**Moorhead Area Public Schools
Grades 5-6 Addition at Horizon Campus
Moorhead, MN**

**Project No. 15-024
Date: May 11, 2016**

ADDENDUM NUMBER 2

RBC

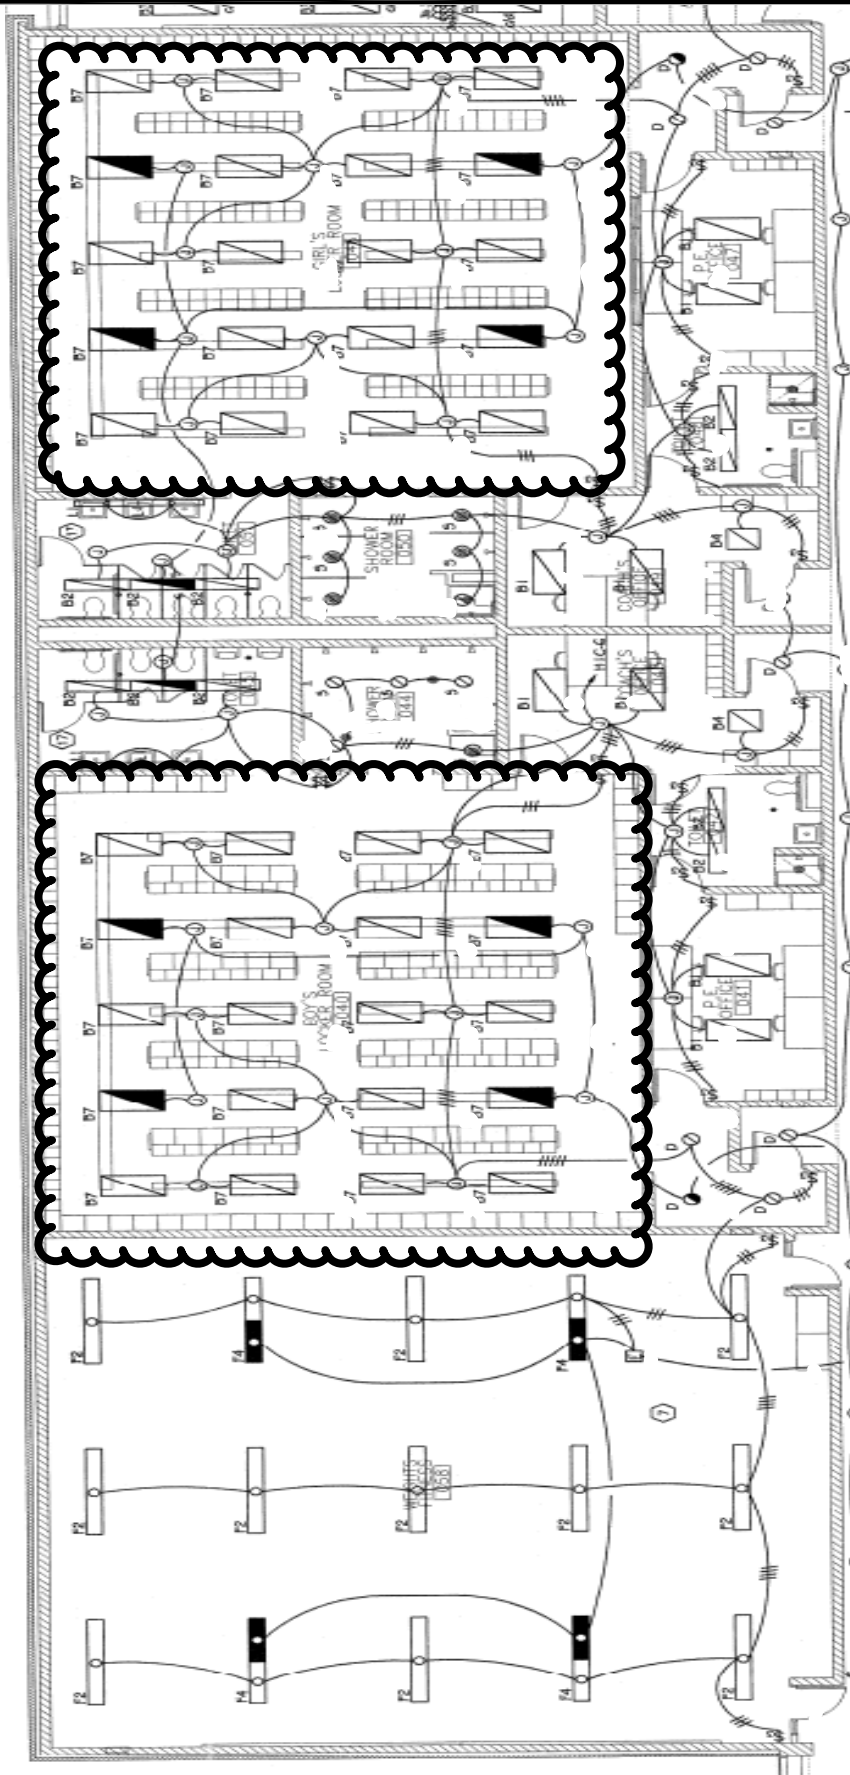
1. See attached drawings E2.15-R2, E2.15-R3, E2.15-R4, E2.15-R5 and E3.15-R1 for work required in the existing building cafetorium.
2. See attached drawing RBC for the antenna booster system drawing referred to in General Item #1 in Addendum #1.
3. See attached Panel Schedule LS2 for the panel schedule referred to for Sheet E6.1, Item #2 in Addendum #1.

1 EXISTING ADMINISTRATION AREA DEMOLITION

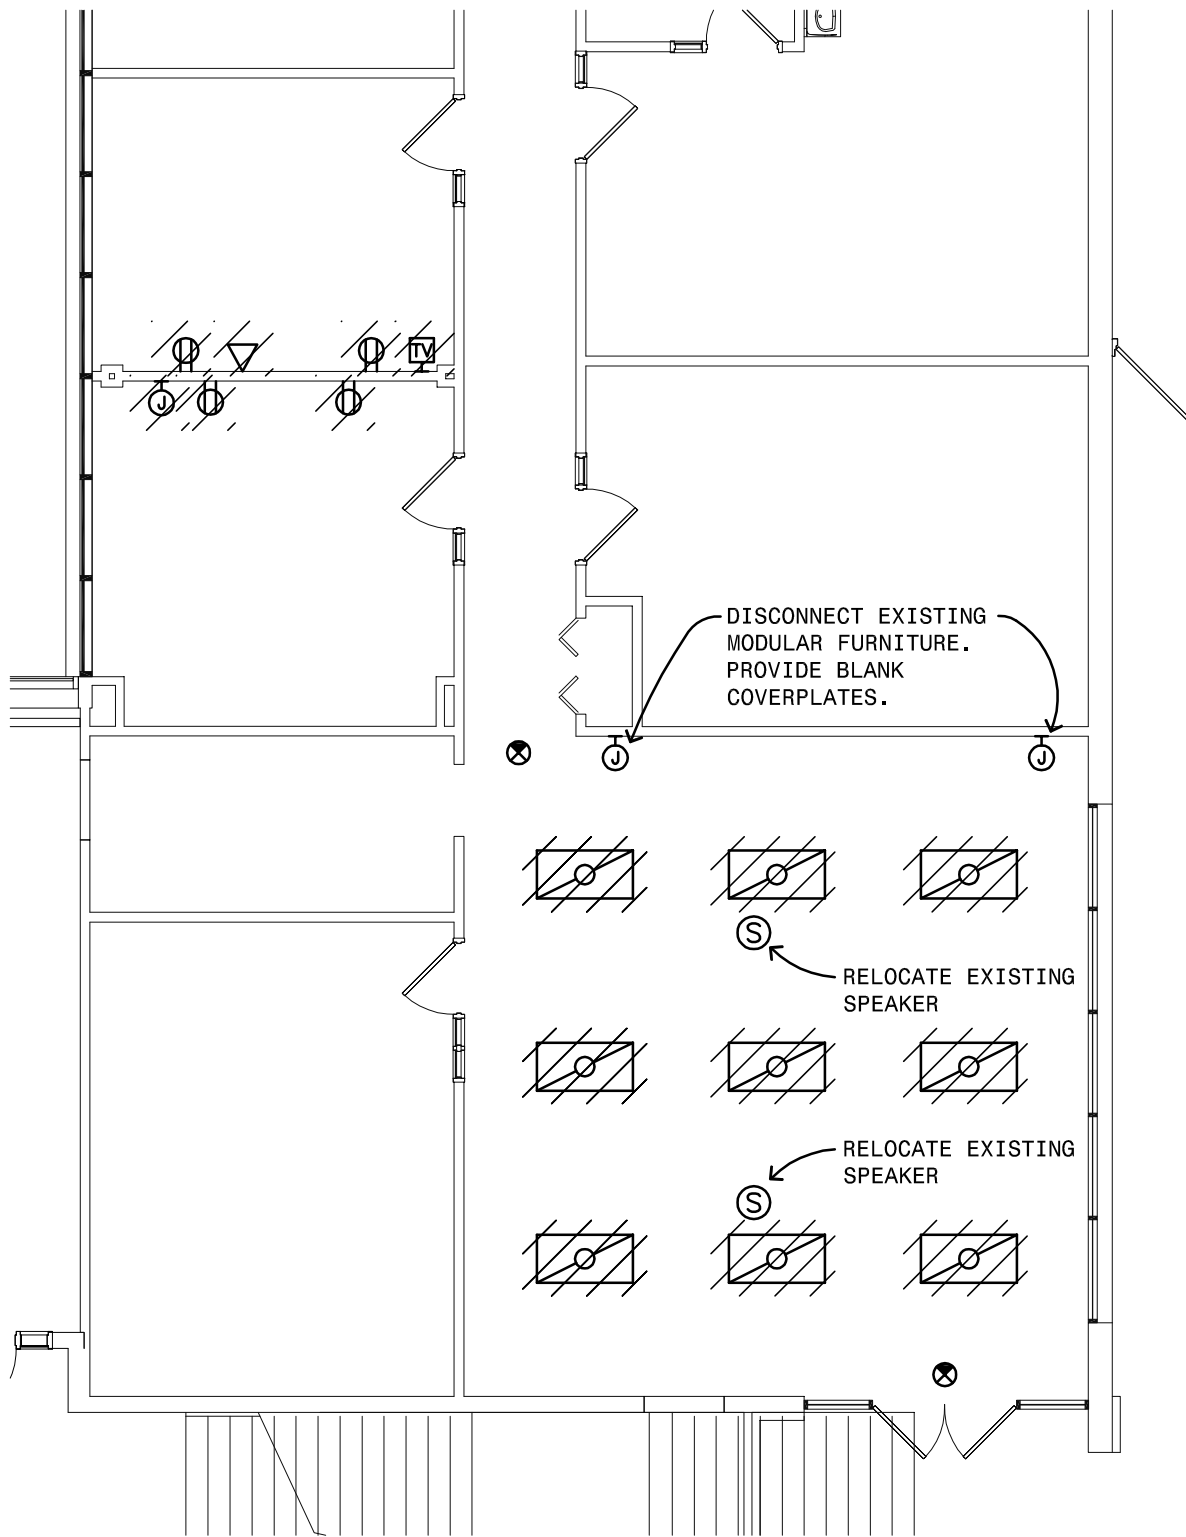
1. Add additional demolition work as shown on attached drawings E1.01-R1 and E1.01-R2.
2. At the north end of the plan where the demolition is shown for the vestibule provide (4) Type 'C' fixtures and (1) Type 'E' fixture to be installed in a new grid ceiling and connected to the existing building corridor lighting circuits.
3. At the north end of the plan where the demolition is shown for the vestibule – Provide demolition for the room above this area. Demolition to include removal of (6) surface mounted fluorescent wraps, (2) ceiling mounted speakers, (1) fire alarm horn/strobe, (1) clock/speaker, (2) receptacles and a TV outlet. Provide (4) Type 'C' fixtures and (1) Type 'E' fixture to be installed in a new grid ceiling and connected to the existing building corridor lighting circuits.

NOTE: DISCONNECT,
REMOVE AND REINSTALL
EXISTING LIGHT FIXTURES
IN THE CLOUDED
EXISTING ROOMS AS
REQUIRED FOR
STRUCTURAL WORK
ABOVE THE CEILING

EXISTING LIGHTING REPLACEMENT

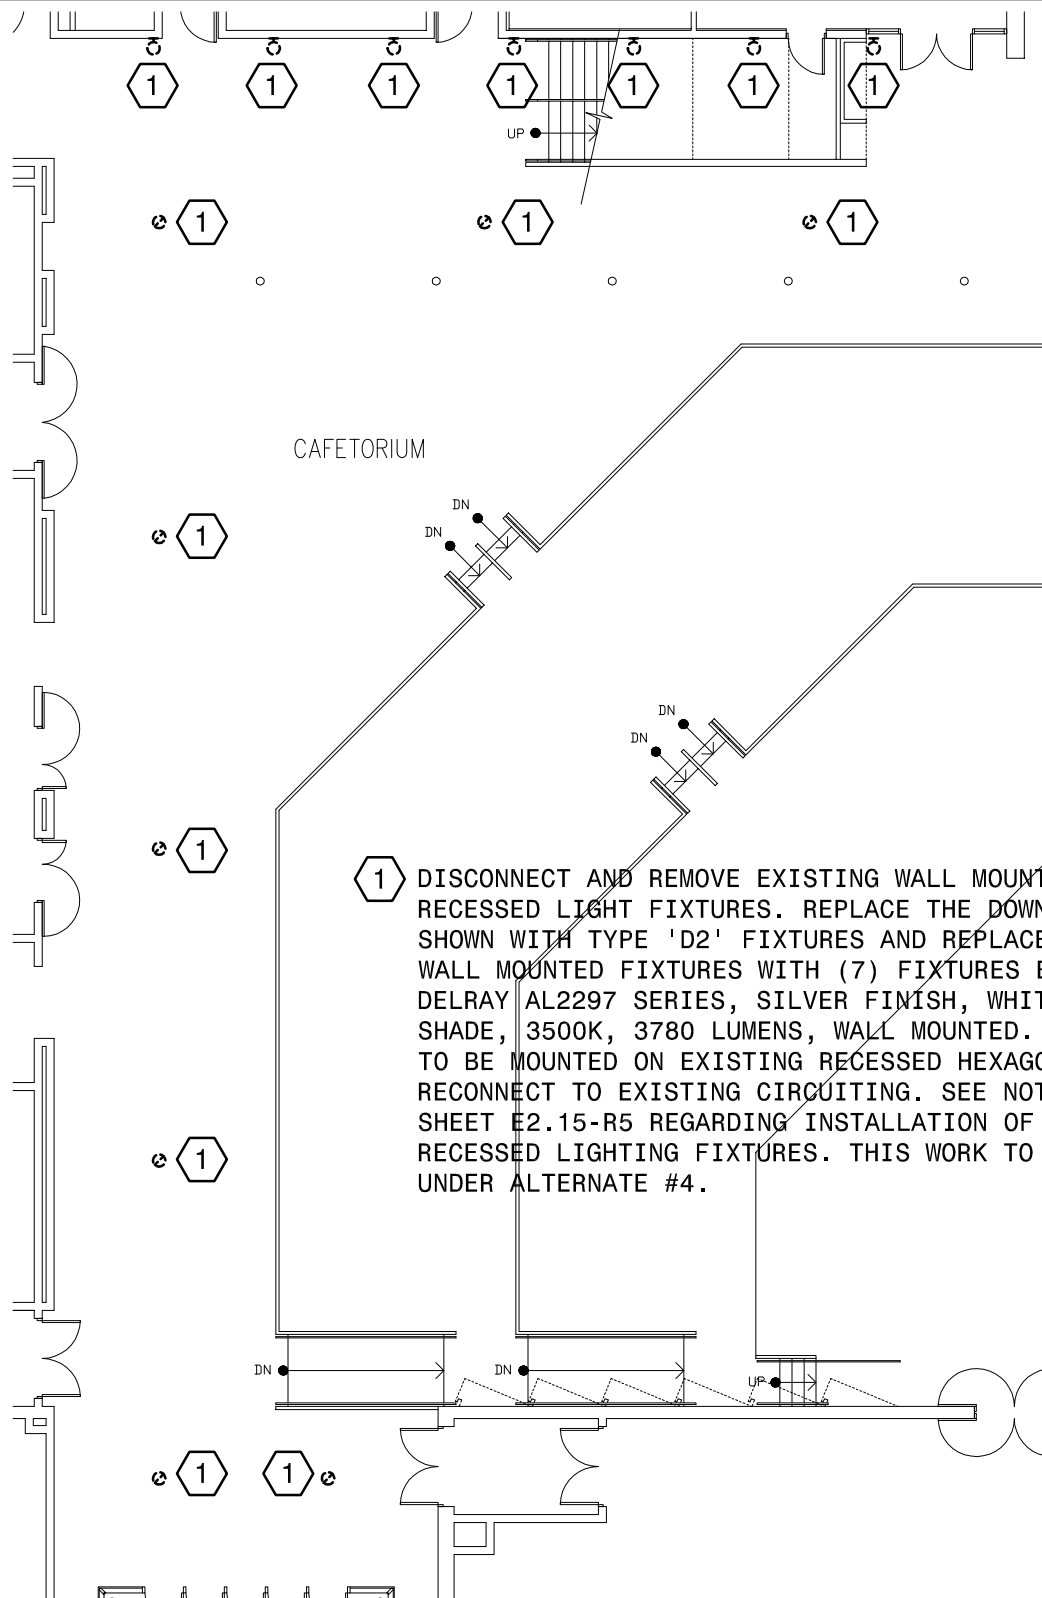
- 1 DISCONNECT AND REMOVE EXISTING SUSPENDED AND RECESSED LIGHT FIXTURES. REPLACE THE DOWNLIGHTS WITH (4) TYPE 'D2' FIXTURES AND REPLACE THE (4) SUSPENDED FIXTURES WITH (4) FIXTURES EQUAL TO DELRAY AL2277 SERIES, SILVER FINISH, WHITE GLASS SHADE, 3500K, 3780 LUMENS, 8 FOOT PENDANT LENGTH TO BE FIELD ADJUSTED TO MATCH EXISTING VARYING PENDANT LENGTHS. RECONNECT TO EXISTING CIRCUITING. THIS WORK TO BE DONE UNDER ALTERNATE #4.

1 DISCONNECT AND REMOVE EXISTING WALL MOUNTED AND RECESSED LIGHT FIXTURES. REPLACE THE DOWNLIGHTS SHOWN WITH TYPE 'D2' FIXTURES AND REPLACE THE (7) WALL MOUNTED FIXTURES WITH (7) FIXTURES EQUAL TO DELRAY AL2297 SERIES, SILVER FINISH, WHITE GLASS SHADE, 3500K, 3780 LUMENS, WALL MOUNTED. FIXTURE TO BE MOUNTED ON EXISTING RECESSED HEXAGONAL BOX. RECONNECT TO EXISTING CIRCUITING. SEE NOTES ON SHEET E2.15-R5 REGARDING INSTALLATION OF NEW RECESSED LIGHTING FIXTURES. THIS WORK TO BE DONE UNDER ALTERNATE #4.

1 RELIEF FAN ELECTRICAL CONNECTION

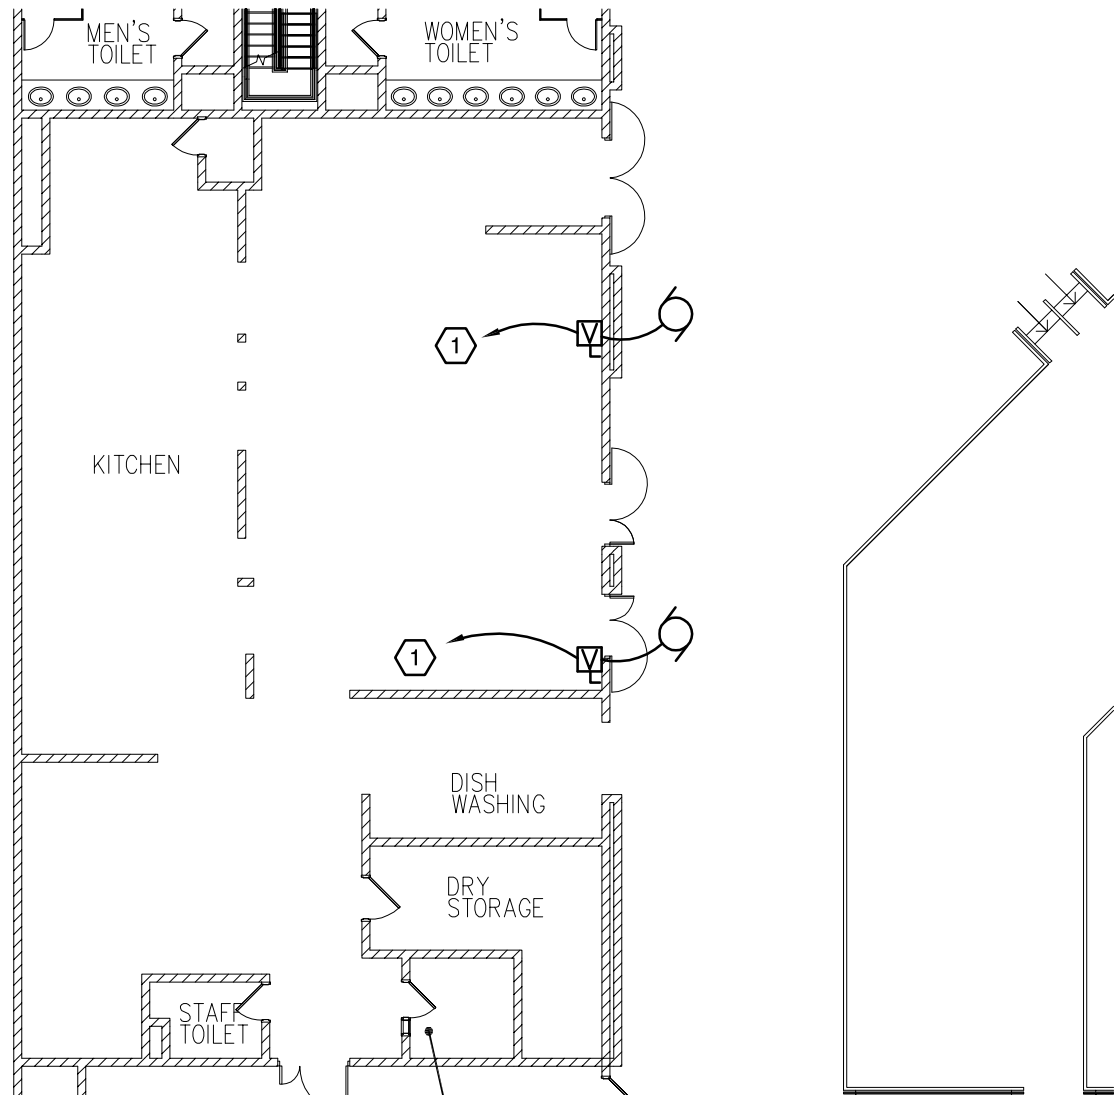
- 1 PROVIDE 480 VOLT, 3-PHASE CONNECTION TO NEW 5 H.P. BUILDING RELIEF FAN. PROVIDE HOMERUN TO EXISTING PANEL H1D. EXISTING PANEL H1D IS LOCATED NEXT TO EXISTING PANEL HLS AS SHOWN ON SHEET E0.03. REPLACE (6) EXISTING 20/1 BREAKERS IN EXISTING SIEMENS PANEL H1D WITH (2) NEW 15/3 BREAKERS. VFDS WILL BE PROVIDED BY DIVISION 23 AND INSTALLED BY DIVISION 26. THE VFDS ARE TO BE LOCATED IN THE MECHANICAL ROOM LOCATED ABOVE THIS LOCATION.
